RESPONSE TO TECHNICAL NOTICE OF
DEFICIENCY
PERMIT MODIFICATION REQUEST
Reconfiguration of Block O

City of Nacogdoches Landfill
Nacogdoches, Texas
TCEQ Permit No. MSW-720

Subject: City of Nacogdoches Landfill – Nacogdoches County
Municipal Solid Waste (MSW) – MSW Permit No. 720
Response to Technical Notice of Deficiency (NOD)
Permit Modification Request – Reconfiguration of Block O
Tracking No. 29534833; RN102217395/CN600134076

DATE: 5/7/24	DATE: 5/7/24	DRAWN BY: JKR	CHECKED BY: JKR	APP. BY: JKR	APP. BY: JKR
DATE: 5/7/24	DATE: 5/7/24								
DRAWN BY: JKR	CHECKED BY: JKR								
APP. BY: JKR	APP. BY: JKR								
CADD FILE: Dwg 1A - FINAL CONTOUR MAP-402									
DATE: 6-2011									
SCALE: AS SHOWN									
DRAWING NO. 7A

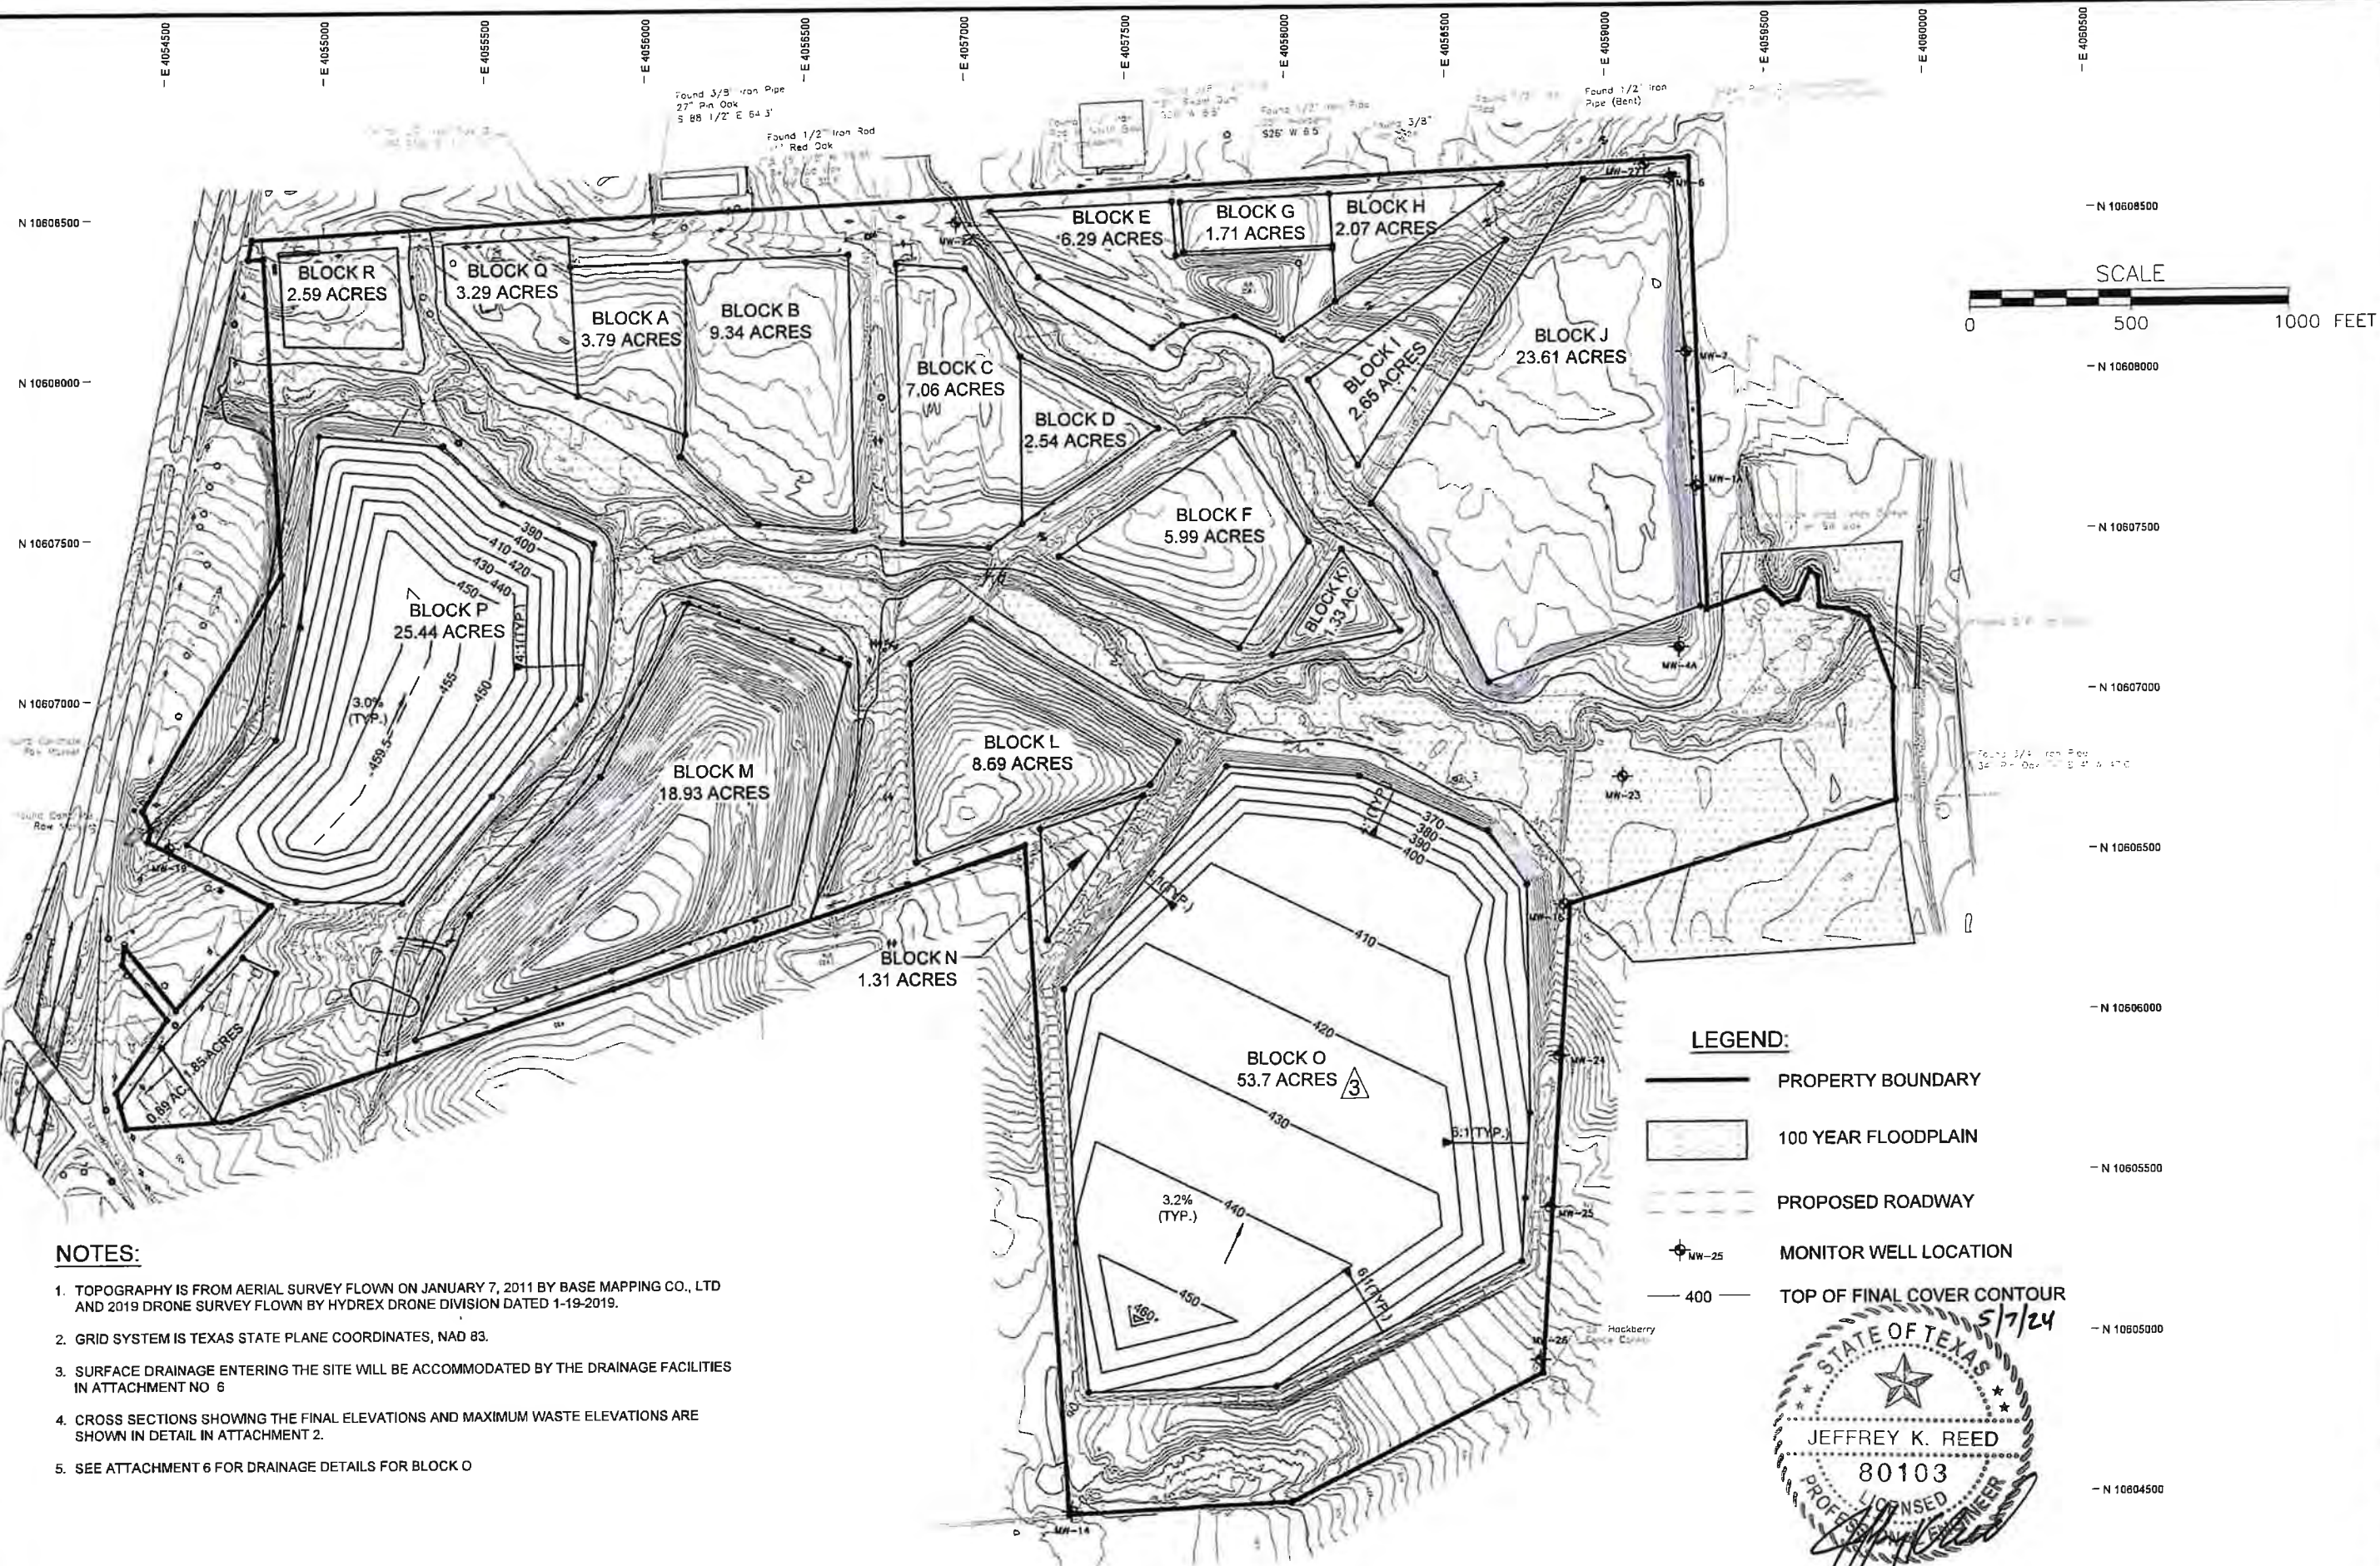
In PDF-I-1, page 113 is missing the professional engineer seal. Please add the P.E. seal to the Drawing No. 7A.

PDF-I-1, page 113 or permit drawing 7A – III.1.1.G Attachment 7 – Final Contour Map is resubmitted with seal, date and signature.

Figure 1. Section Location Plan for Section AA' and CC'

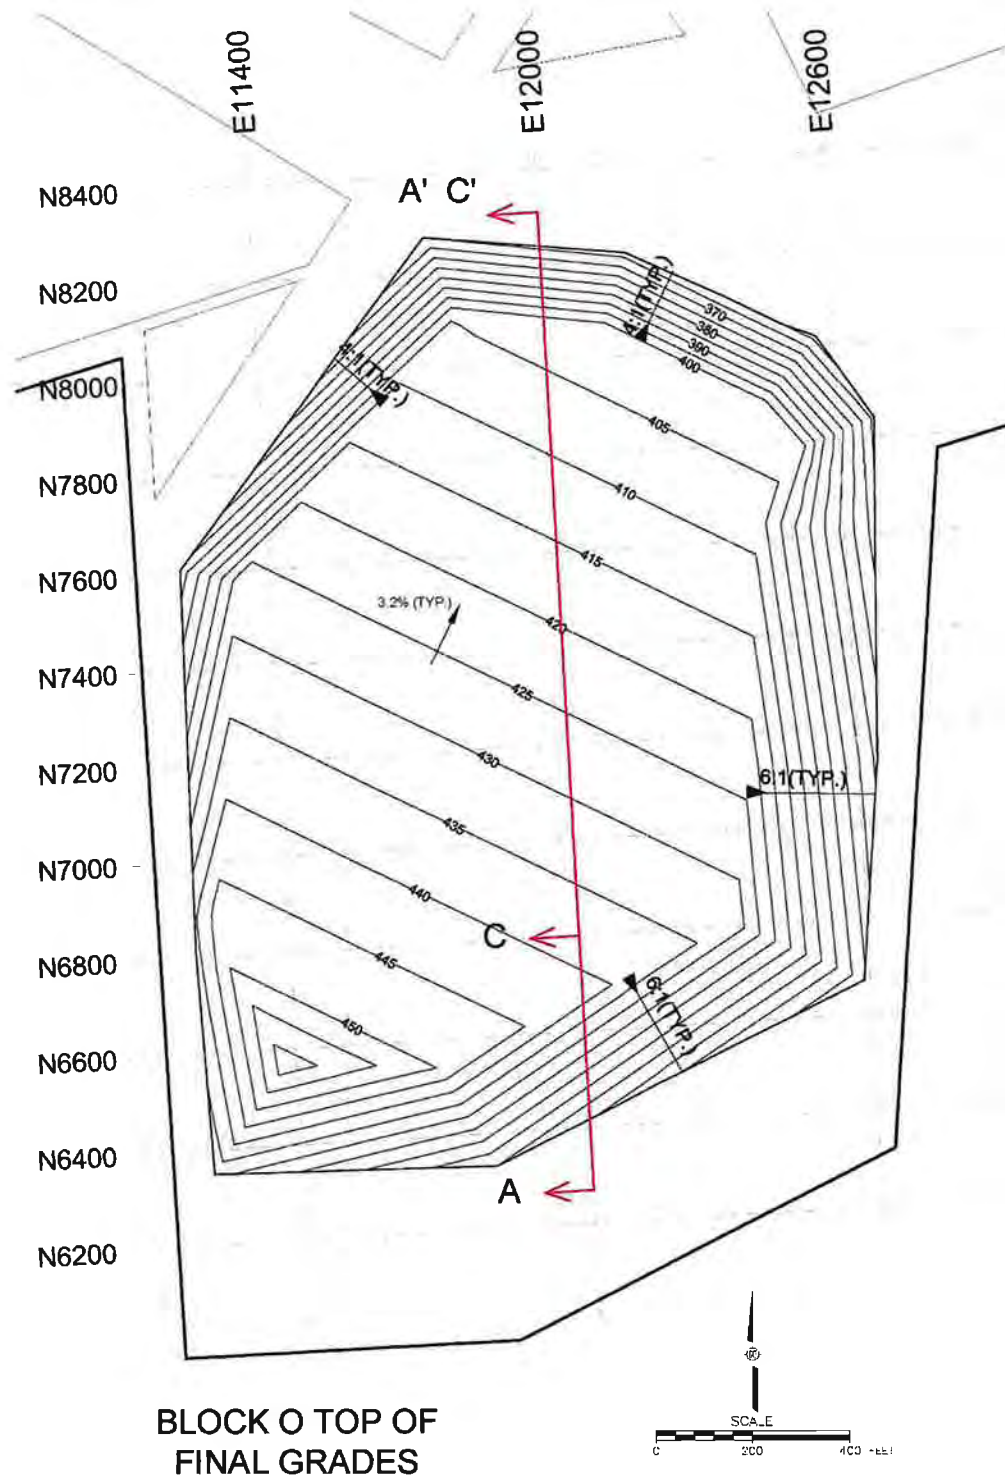
In PDF-I-2 page 16, plot the locations for both AA' and CC' on this plan map, and change the figure title to "for Section AA' & CC'" to be consistent with PDF-I-2 page 17.

PDF-I-2, page 16 or permit page C-1-8 is revised to show both AA' and CC' on the plan map and changed the Figure 1 title to "Section Location Plan for Section AA' and CC'".

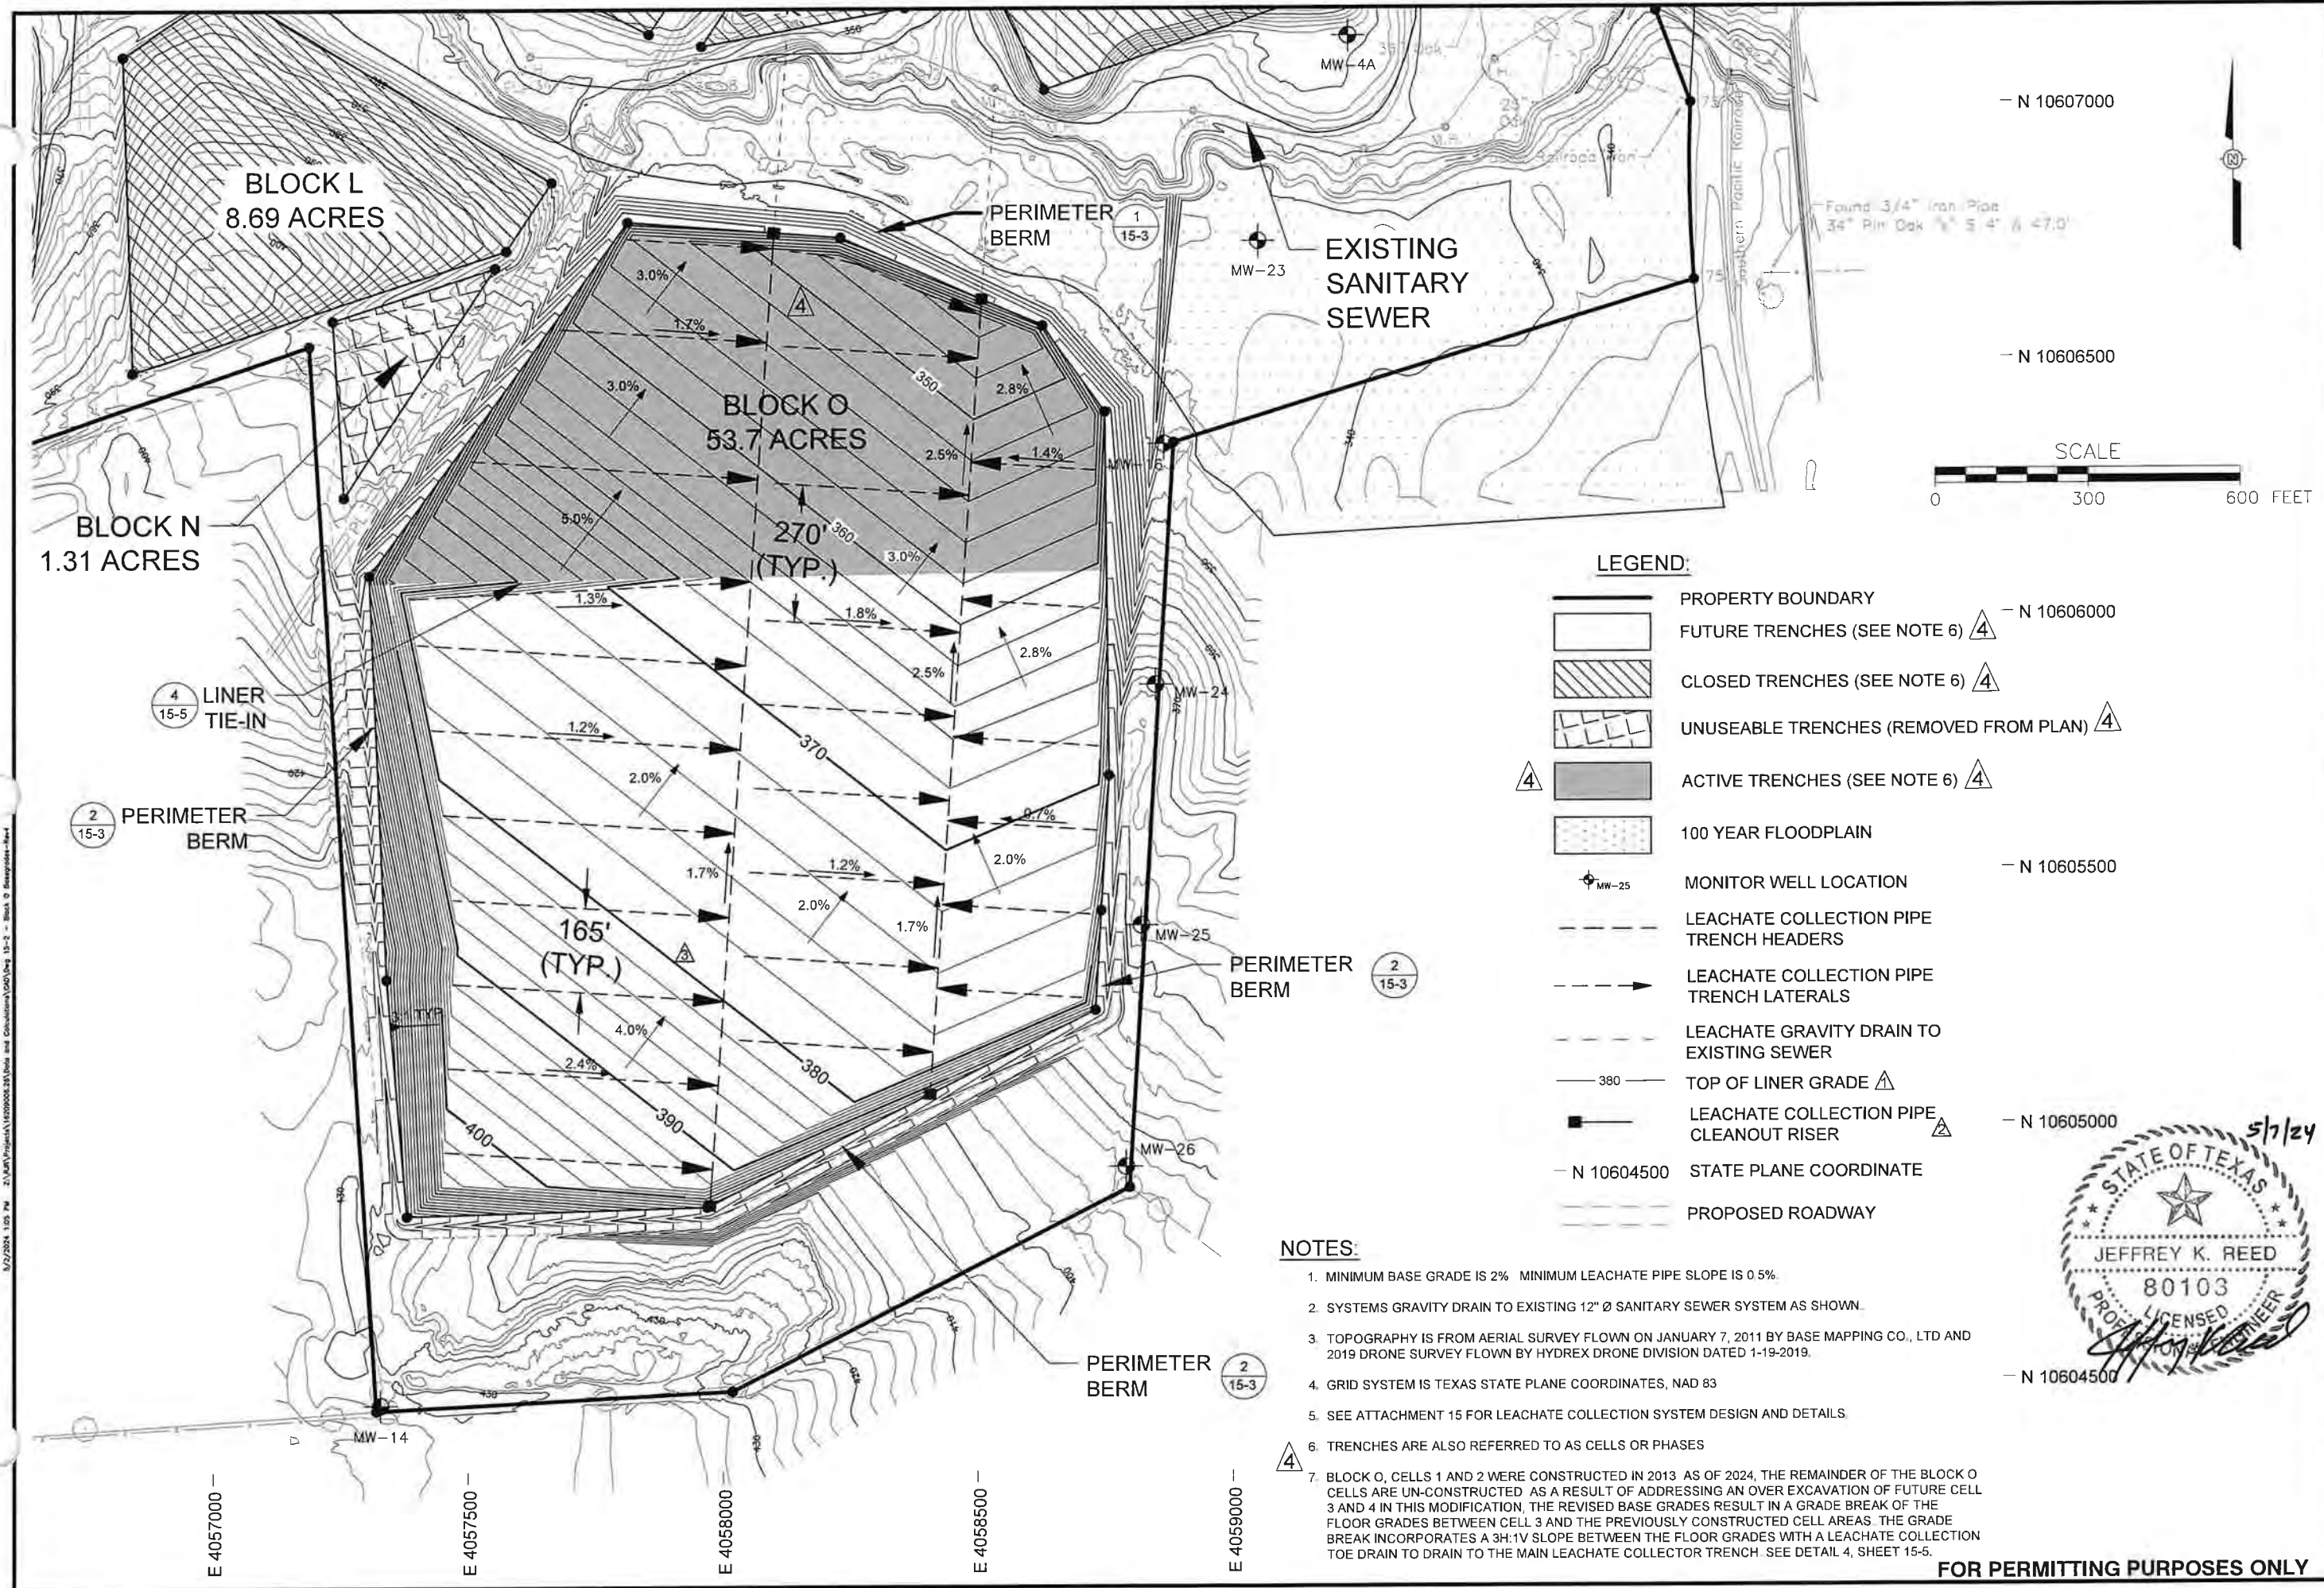
In PDF-I-2 page 124, on DWG 15-2, please add narrative to explain the grade break in the NW corner of the block, in reference to this figure. Include further details beyond the brief entry of "to compensate for over excavated area of future cell" on the application form. Provide a summary of the history (e.g. add details of the footprint reduction, the subsequent changes to Blocks P and O, etc.).

In PDF-I-2 page 124, DWG 15-2, please clarify the meaning of "Trench" as used in the figure. Alternatively, a note could be added to the figure next to each use of "Trench" to indicate the meaning of the references, e.g., future blocks, closed blocks or closed trench fills, etc.

In PDF-I-2 page 124, DWG 15-2, please change "Unusable" to "Removed From Plan".

PDF-I-2, page 124 or permit drawing 15-2 – Base Grades – Block O is revised to include a note providing additional information regarding the grade break in the NW corner of the block, as well as a brief history. Additionally, a detail was added to permit drawing 15-5 – Liner System Details for the grade break.

PDF-I-2, page 124 or permit drawing 15-2 – Base Grades – Block O is revised to include a note that indicates the "Trenches" reference may also be referred to as "Cell" or "Phase".

PDF-I-2, page 124 or permit drawing 15-2 – Base Grades – Block O revised to clarify that "Unusable Trenches" have been removed from plan.

7. BLOCK O, CELLS 1 AND 2 WERE CONSTRUCTED IN 2013 AS OF 2024, THE REMAINDER OF THE BLOCK O CELLS ARE UN-CONSTRUCTED AS A RESULT OF ADDRESSING AN OVER EXCAVATION OF FUTURE CELL 3 AND 4 IN THIS MODIFICATION, THE REVISED BASE GRADES RESULT IN A GRADE BREAK OF THE FLOOR GRADES BETWEEN CELL 3 AND THE PREVIOUSLY CONSTRUCTED CELL AREAS. THE GRADE BREAK INCORPORATES A 3H:1V SLOPE BETWEEN THE FLOOR GRADES WITH A LEACHATE COLLECTION TOE DRAIN TO DRAIN TO THE MAIN LEACHATE COLLECTOR TRENCH. SEE DETAIL 4, SHEET 15-5.
